HISTORIC AND DESIGN REVIEW COMMISSION

June 06, 2018

HDRC CASE NO:	2018-182
ADDRESS:	632 LEIGH ST
LEGAL DESCRIPTION:	NCB 2739 BLK LOT W 41.6 FT OF A19
ZONING:	R-5, H
CITY COUNCIL DIST.:	1
DISTRICT:	Lavaca Historic District
APPLICANT:	Veronica Montemayor
OWNER:	Veronica Montemayor
TYPE OF WORK:	Construction of a two story, single family residential structure; installation of solar
	panels
APPLICATION RECEIVED:	April 13, 2018
60-DAY REVIEW:	June 12, 2018

SITE PLAN Scale 3/16" = 1'-0"

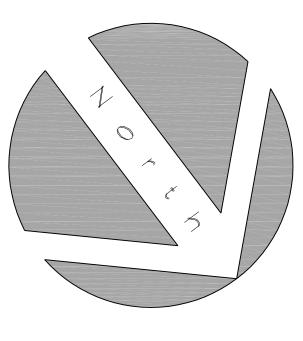
- CARPORT & DRIVEWAY LOCATION The development pattern along Leigh includes side yard parking in driveways located on both the east and west sides of the primary structure. The applicant has proposed a curved driveway which terminates at the front façade of the proposed new construction, resulting in front yard parking and a carport on the front façade. This is not consistent with the development pattern found along the block. Additionally, front loading garages and front yard parking are not found historically within the Lavaca Historic District. Staff finds that the proposed parking location should be modified to be located in the side yard.

- iv. That the proposed, front loaded carport and curved driveway be modified to not result in front yard parking as noted in finding l. The propose driveway should be straight and feature no more than ten (10) feet in width to match those found historically in the district.
